UCC29950: START UP PLAN AND FEEDBACK WITH DIFFERENT VALUES  $R_{top}$  &  $R_{bttm}$

## UCC29950: APPLICATION FOR 325V OUTPUT FROM “BUCKBOOST” : SEPIC POWER STAGE

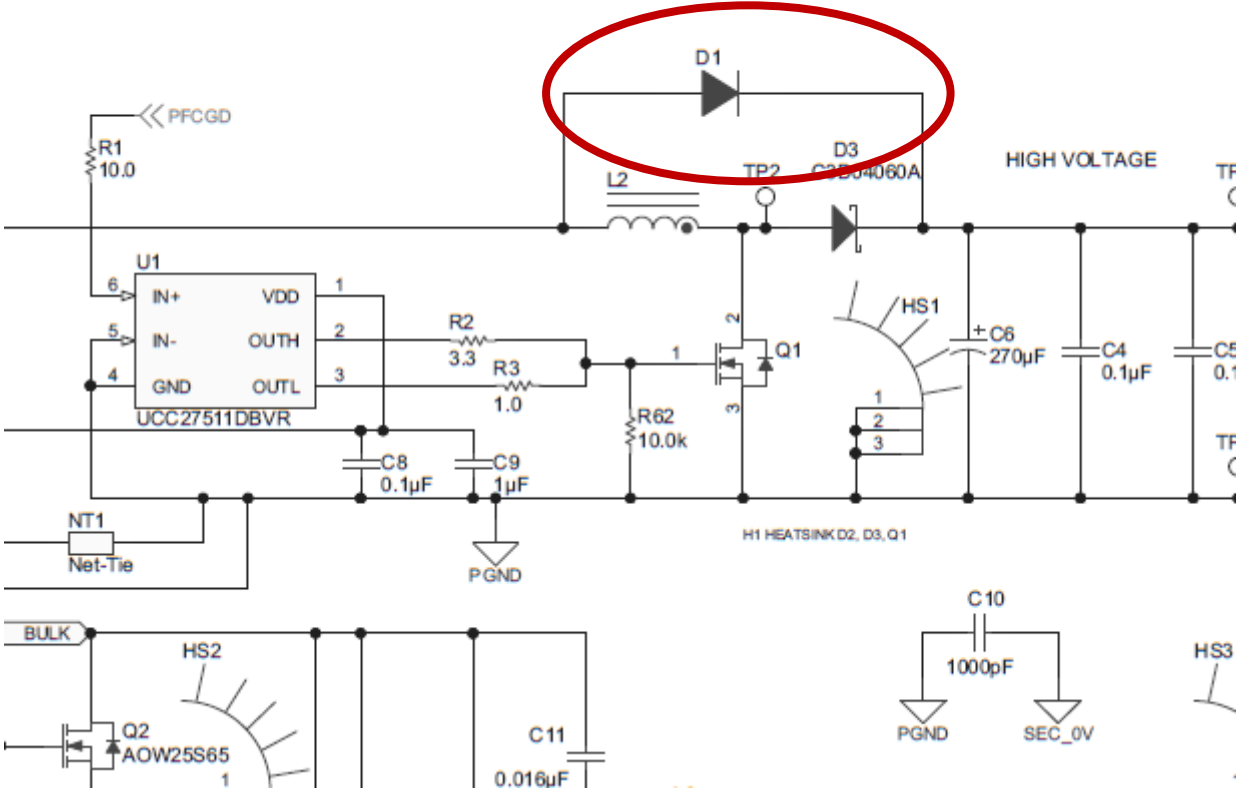
Adding D1 implies  $V_{bulk}$  side expects to see initial instantaneous voltage from AC line to start the controller

Is it not enough to get Vbulk regulation value from any output?			
$V_{BULK(reg)}$	$V_{BULK}$ regulation set-point	0.907	<b>0.940</b>	0.973	V
$V_{BULK(IIc\_start)}$	LLC operation start threshold	0.70	0.73	0.77	V
$V_{BULK(IIc\_stop)}$	LLC operation stop threshold	0.45	0.49	0.53	V

### 7.3.2 Sense Network Fault Detection Is this true or is this a bit confusing? Besides, D1 in the App ckt defeats it and will cause uncontrolled Inrush current

Is this true or is this a bit confusing? Can UCC29950 be used in our topology of SEPIC buckboost with  $V_{bulk}=325V$ ?

WHY these limits in a general use controller such as UCC29950
